Rolling Knolls Landfill Superfund SITE
FIELD CHANGE REQUEST (FCR) FORM

REQUEST NO: 02

DATE: 12/11/2014 (Revised 12/19/2014)
(Revised 12/22/2014)

FCR TITLE: Soil Sample Location Modification

Table 1
Revised Sample Locations
 Field Change Request (FCR) Form #02
 Rolling Knolls Landfill Superfund Site
 Chatham, New Jersey

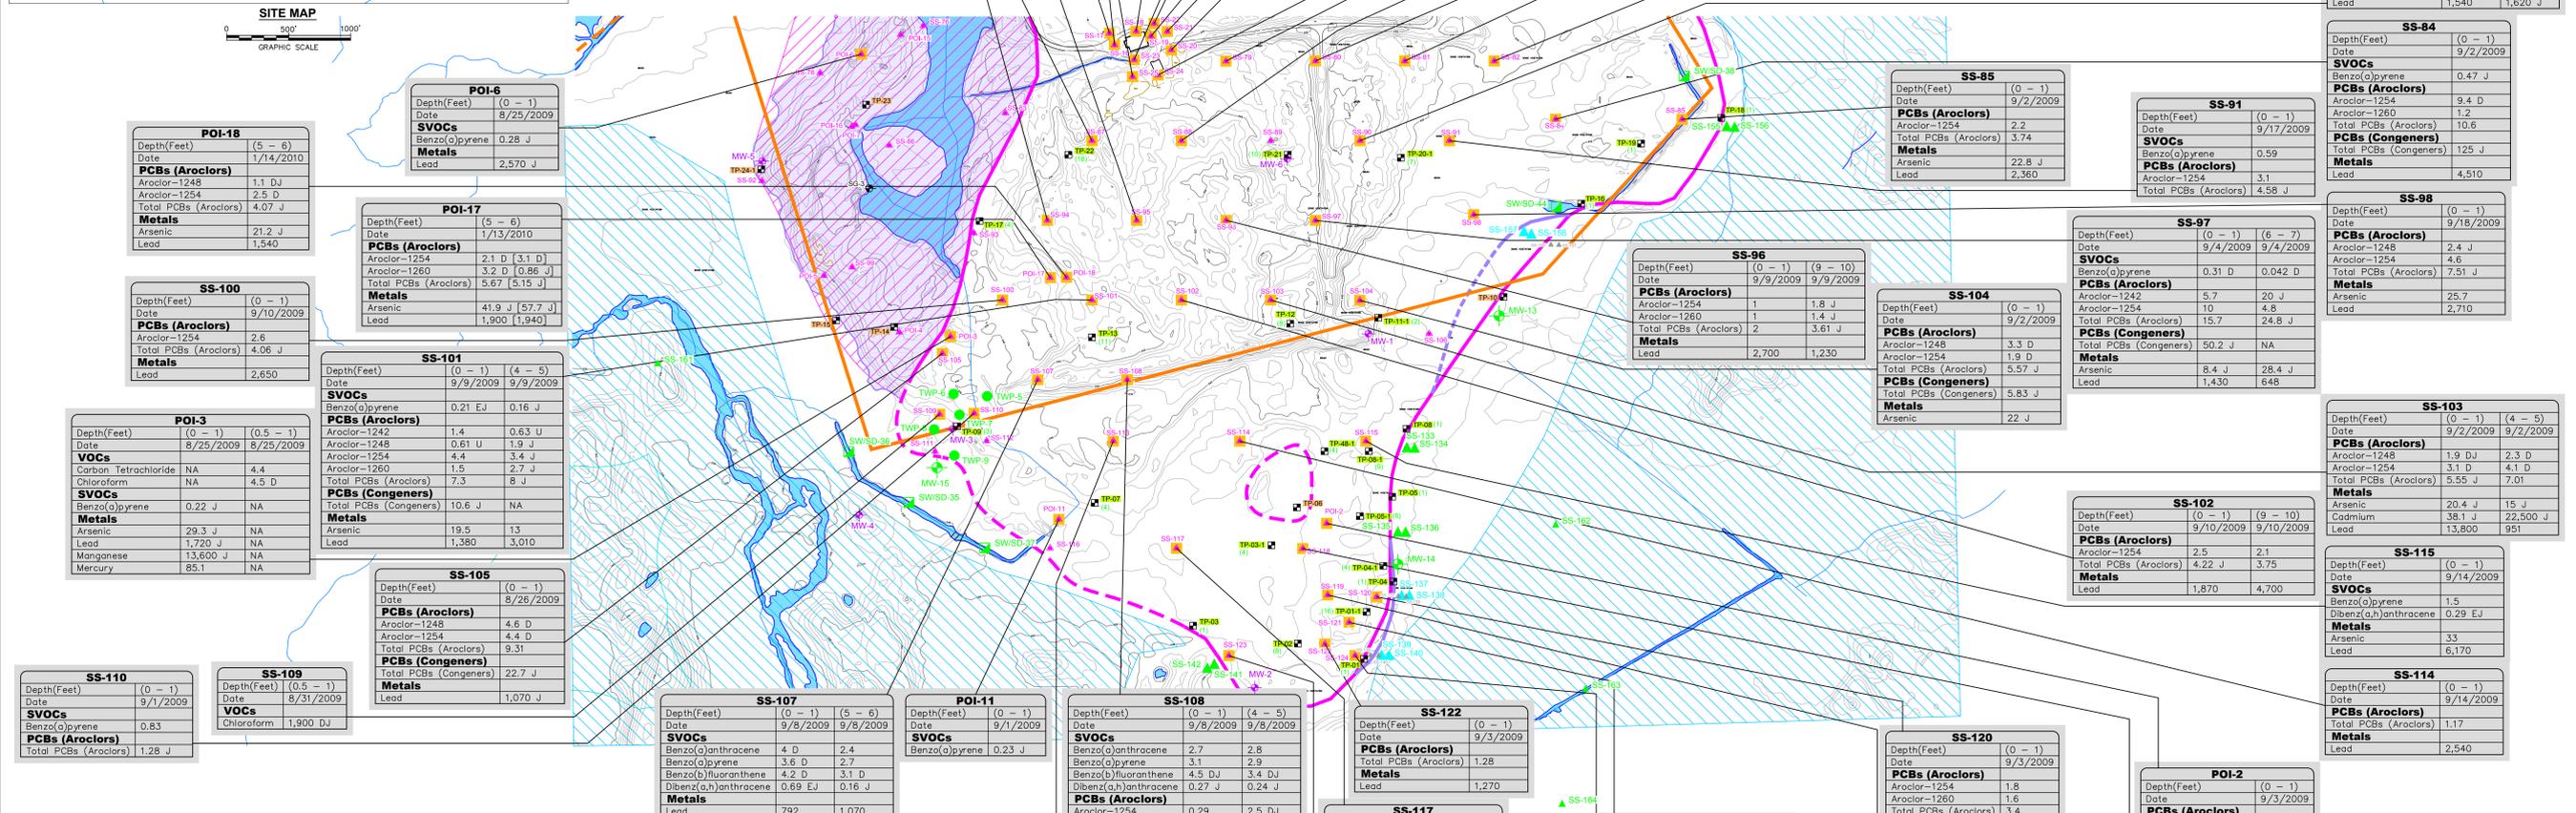
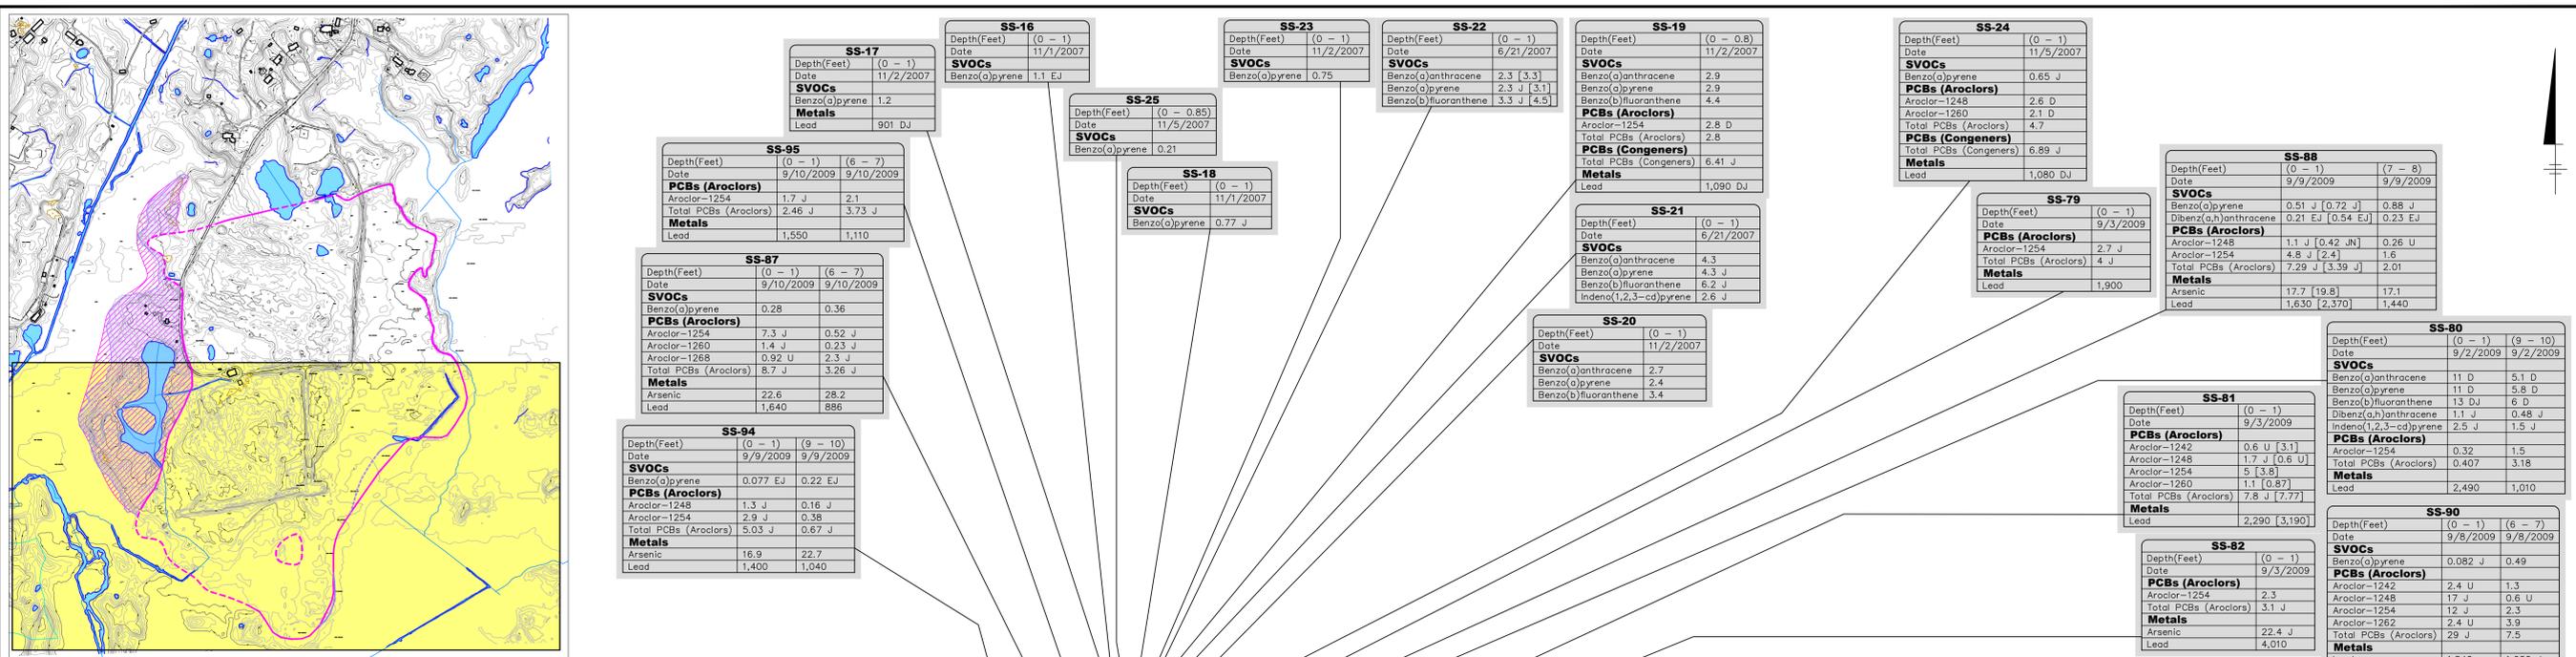
Location	Approximate Distance Moved	Basis for Relocation
Landfill boundary at SS-137	15.3 ft	Visual observation of trash outside original landfill boundary; samples were moved outward.
SS-137	11.0 ft	
SS-138	10.5 ft	
Landfill boundary at SS-139	25.2 ft	Visual observation of trash outside original landfill boundary; samples were moved outward.
SS-139	34.9 ft	
SS-140	34.4 ft	
Landfill boundary at SS-143	117.5 ft	Trash was not observed at the original proposed landfill boundary; samples were moved inward.
SS-143	115.0 ft	
SS-144	113.0 ft	
Landfill boundary at SS-145	24.1 ft	Trash was not observed at the original proposed landfill boundary; samples were moved inward.
SS-145	23.3 ft	
SS-146	24.2 ft	
Landfill boundary at SS-147	11.4 ft	Trash was not observed at the original proposed landfill boundary; samples were moved inward.
SS-147	6.3 ft	
SS-148	0.1 ft	
Landfill boundary at SS-149	15.3 ft	Trash was not observed at the original proposed landfill boundary; samples were moved inward.

SS-149	23.5 ft	
SS-150	31.6 ft	
Landfill boundary at SS-157	95.8 ft	Trash was not observed at the original proposed landfill boundary; samples were moved inward.
SS-157	119.6 ft	
SS-158	70.7 ft
